Environmental Impact Assessment

Screening according to Schedule III of S.L. 549.46

ERA Reference no.: EA/00008/24
PA Reference no.: PA/00335/24
Project Title: Transforming an existing waste treatment site into an urban greening project including excavation, underground parking facilities, educational building, greenhouse, food court and water feature.
Location: Sant Antnin Waste Treatment Plant, Triq Sant' Antnin, Marsascala
Screening date: 27 May 2024

Figure 4: Plan illustrating excavated areas and location of boreholes (Source: PDS)

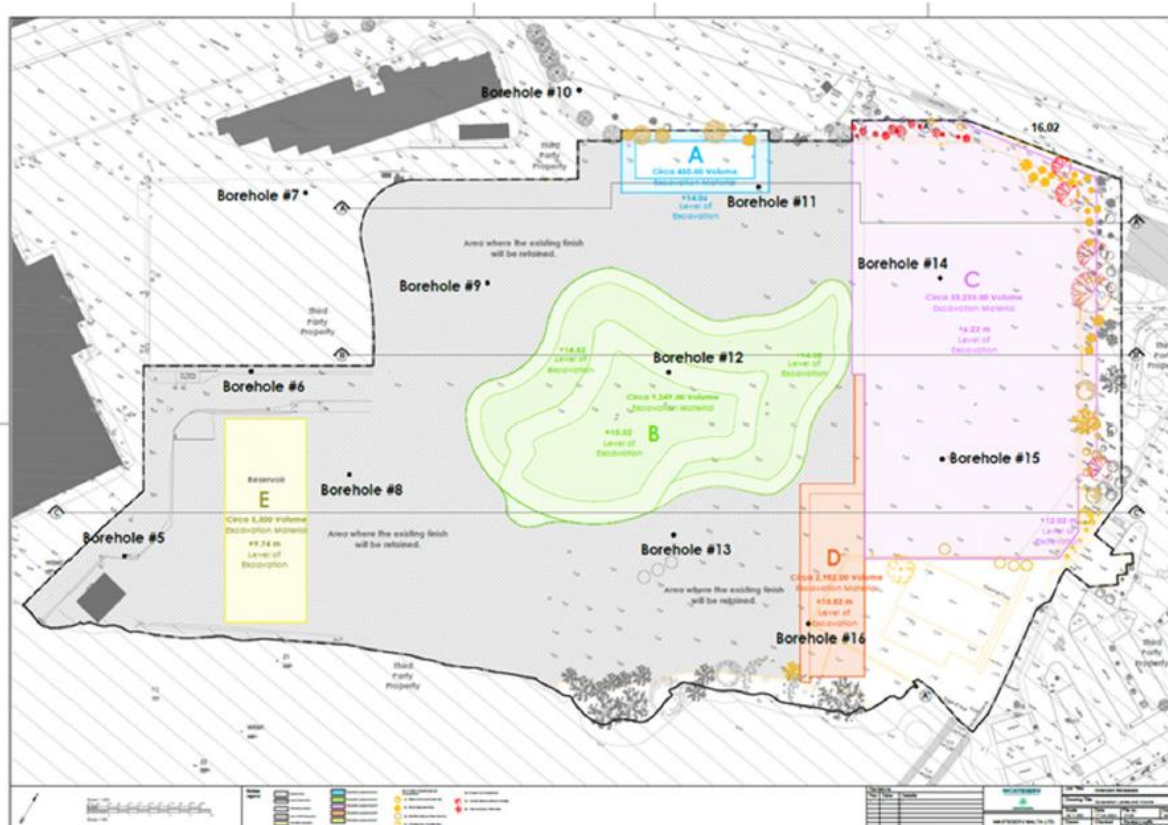
A land and groundwater baseline analysis and a Hazardous Property Assessment of ground samples were also carried out (refer to Figure 4). The fate of the excavated material will depend on the results of these tests, a summary of which is presented in Table 1.

Figure 5: Plan showing the location of excavated material to be re-used on site (Source: PDS)

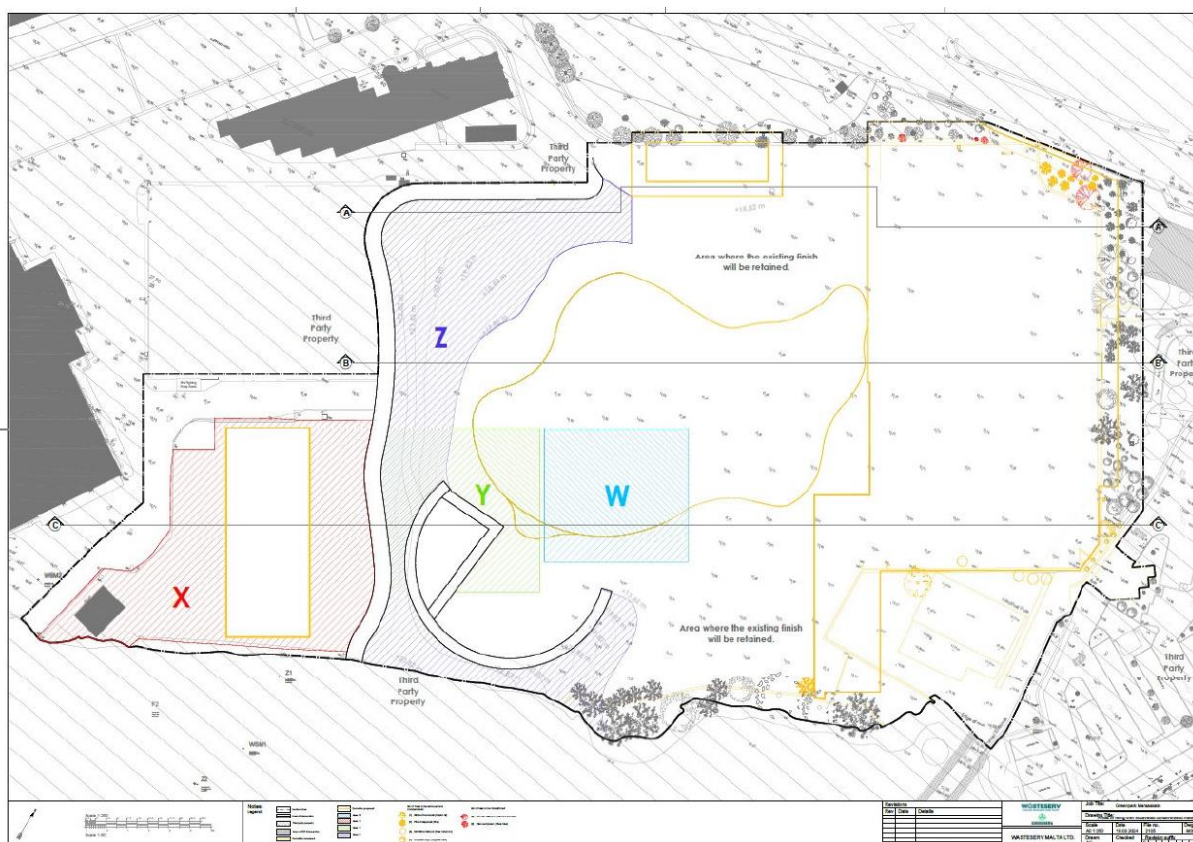
The possibility of integrating the excavated material on site was extensively considered, resulting in 22,958m³ of excavated material to be crushed, graded and re-used on site to reprofile the site [in areas W,X, Y (up till level +15.6m) and Z – as per Figure 5 and Table 2).

Figure 6: Section of the proposed levelling and excavation of reservoir within the industrial area (area X) (Source: PDS)

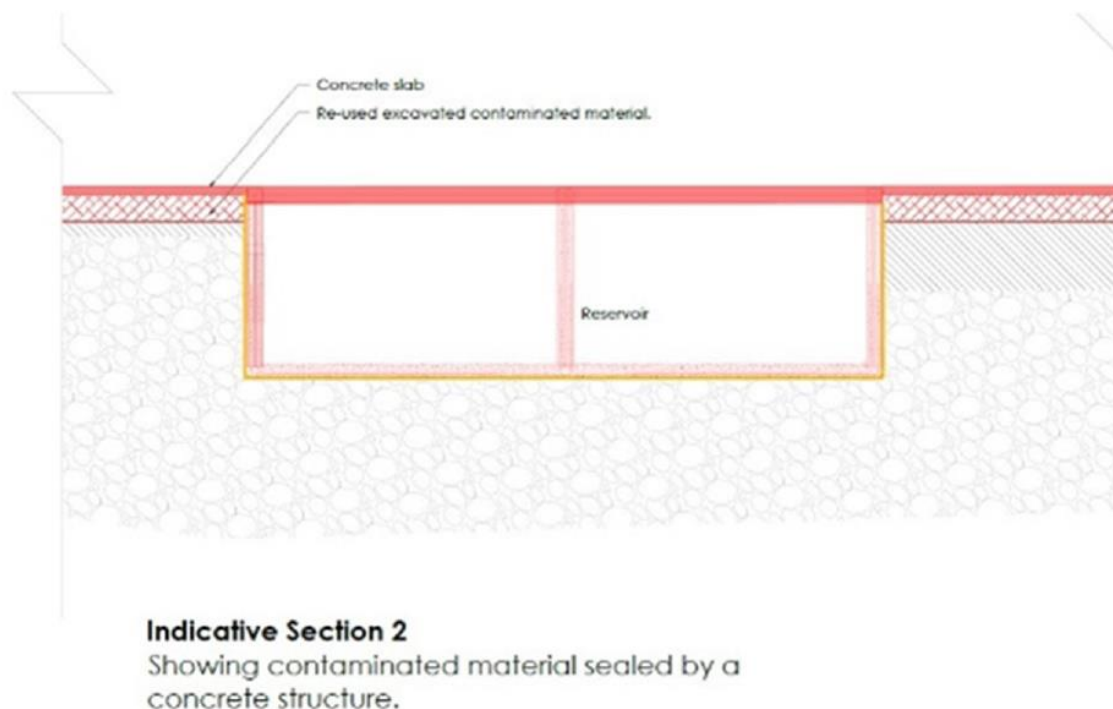
Part of the site of the SAWTP will remain operational for the treatment of glass waste. The said operation is covered by an Environmental Permit (EP 0016/23) granted by ERA in December 2023. Proposed works within the industrial area (in Figure 1) include levelling of the same area and the excavation of a reservoir (section in Figure 6), and the construction of a retaining wall that will separate the said industrial area from the urban greening project. The industrial area will be utilised as a storage area for the glass sorting line.
